Flow Hyundai

Albemarle County, VA

ARB Revisions

RE: ARB-2024-50: Flow Automotive of Charlottesville - Hyundai (TMP: 03200-00-00-02000)

DESIGN REVISIONS

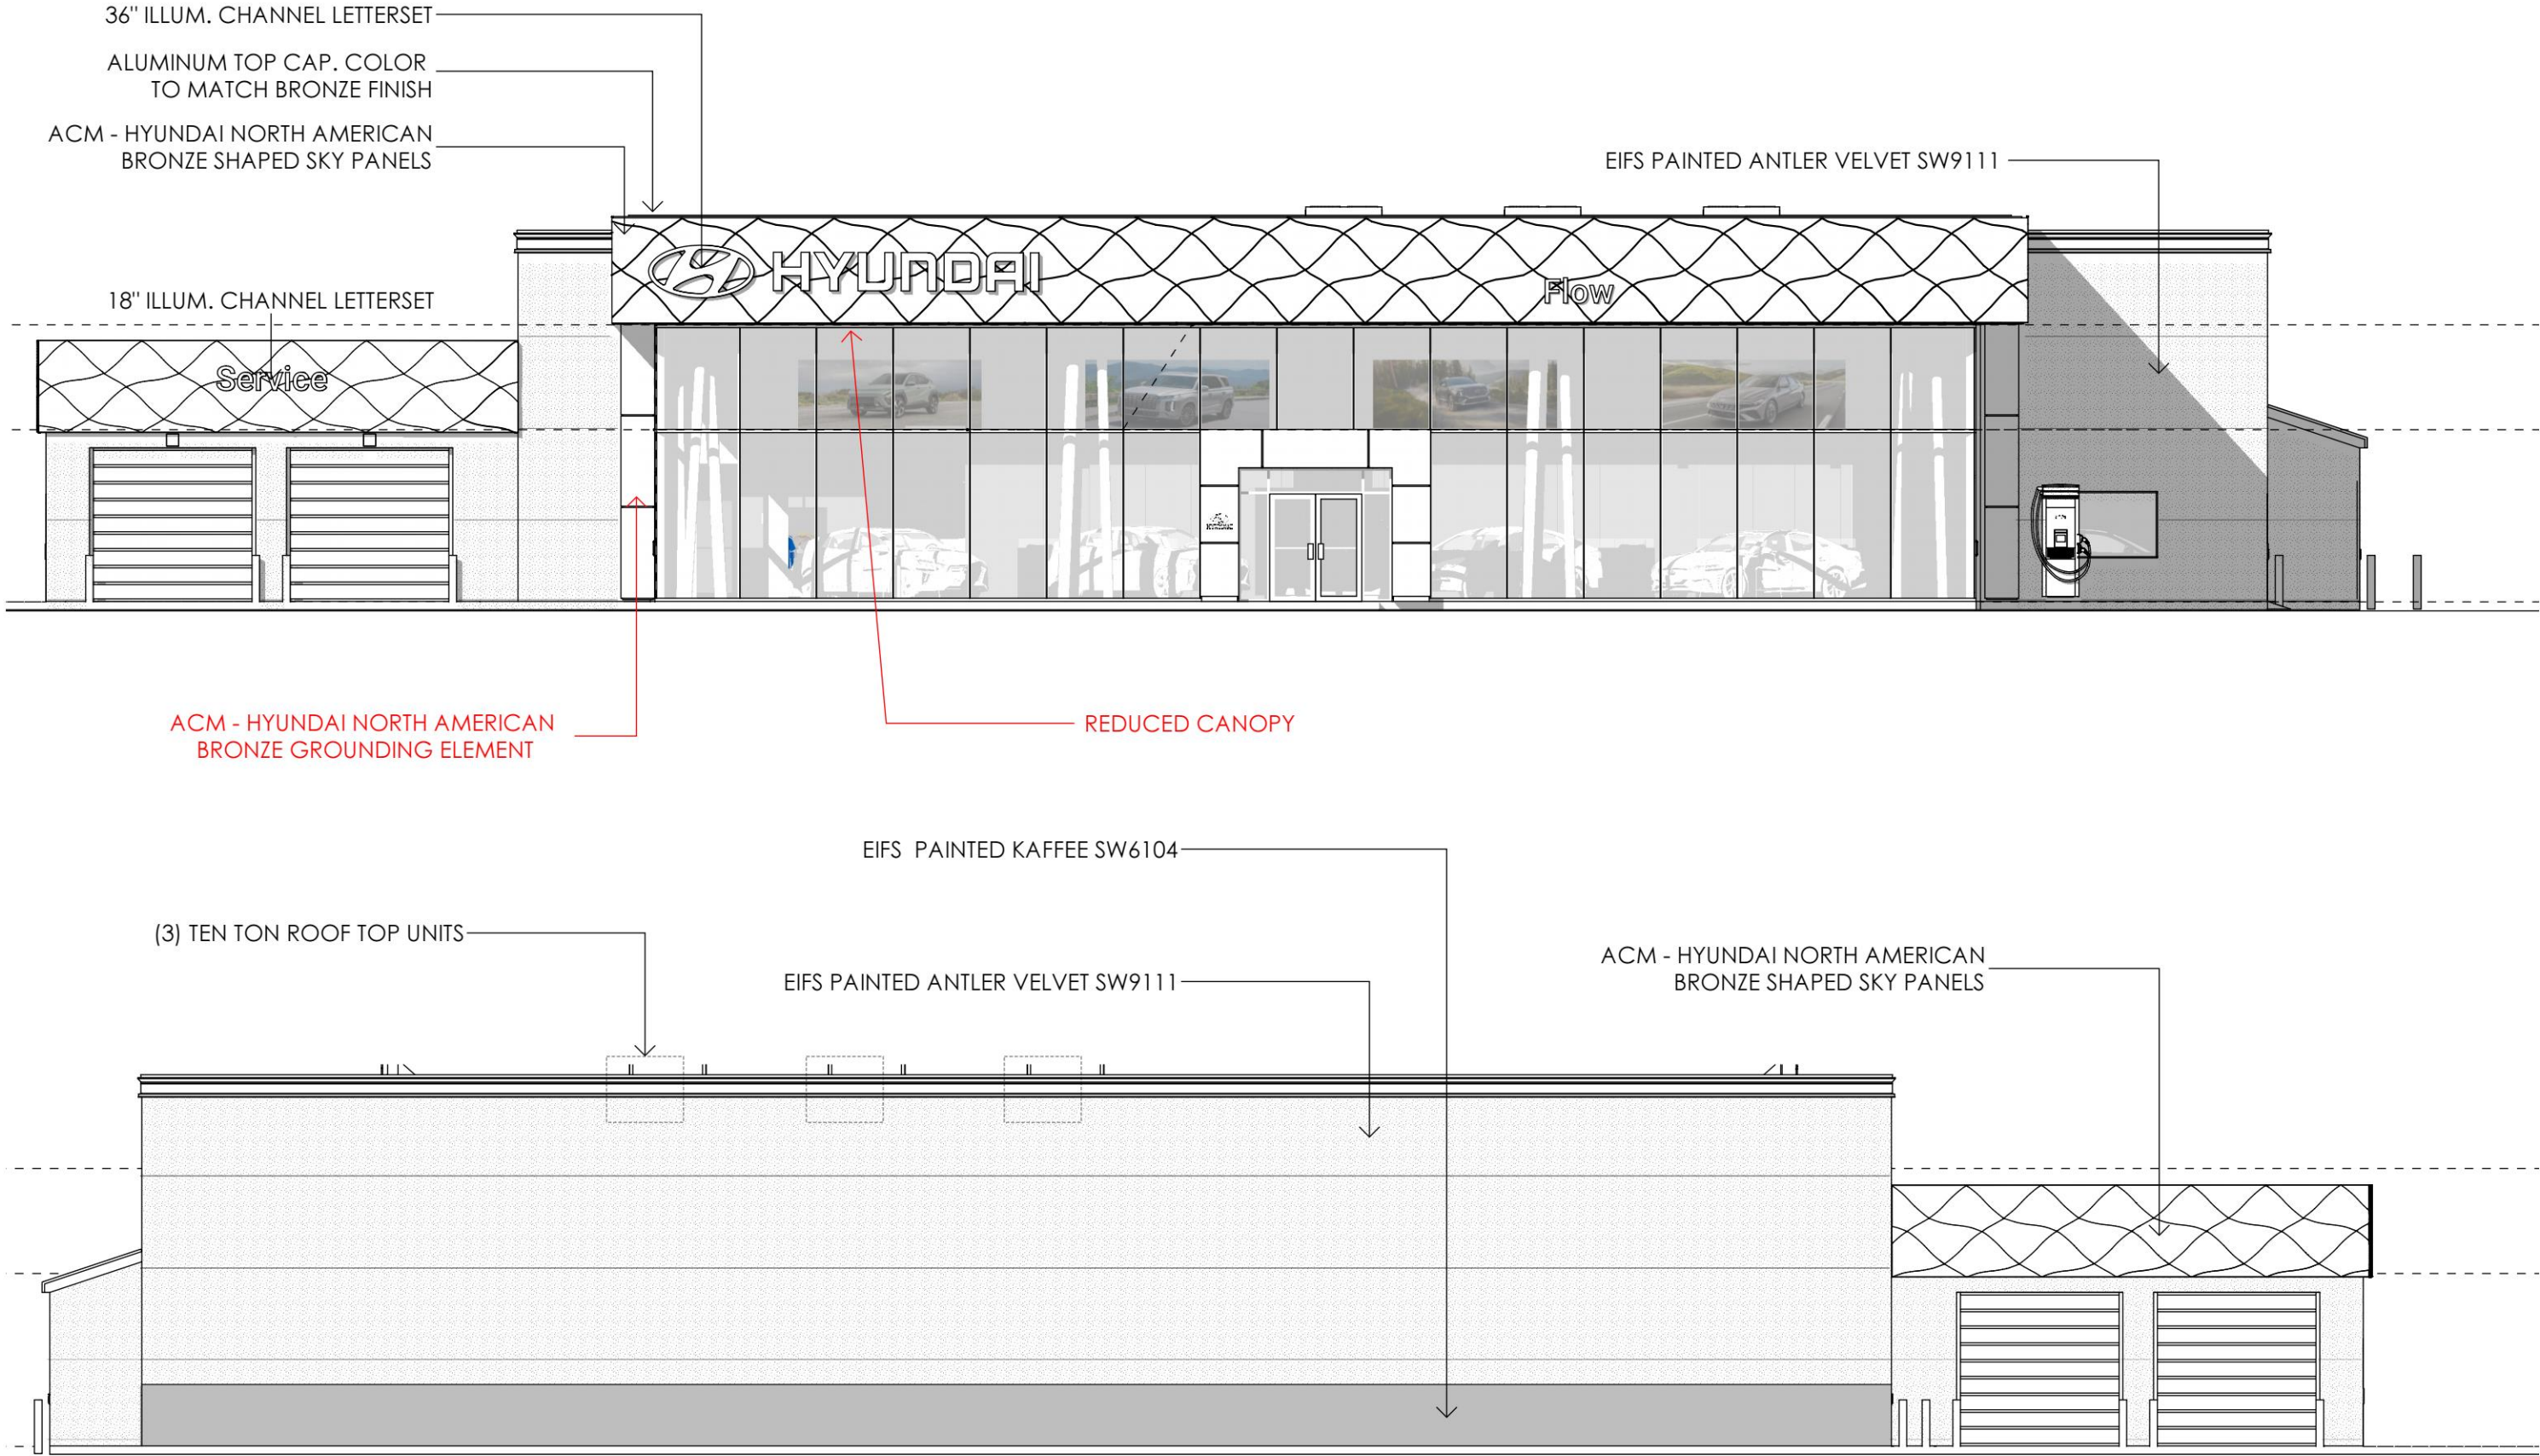
1. Revise the step down of the fascia to a consistent height.
2. Move the tree columns to the exterior; make them more visible.
3. Reduce the fascia height.
4. Consider the rear wall of the showroom as part of the composition visible from the EC if the fully glazed pavilion porch concept is pursued.

1. Design Develop removed the step down fascia to minimize the weight of the of the top heavy feature per the boards comments.
2. The tree columns remain on the interior of the building.
3. The fascia height was reduced by 1' to comply with the boards suggestion to lower the maximum height of the fascia.
4. The rear wall of the showroom acts as a secondary threshold from the showroom to the service center and supports the pavilion motif that was suggested by the board.

Revision 1: Remove stepped fascia and maintain straight line at bottom of fascia.

Revision 2: Reduced height of fascia by 1' but maintained vertical grounding elements.

The rear wall of the showroom acts as a **secondary threshold** from the showroom to the service center and supports the pavilion motif.
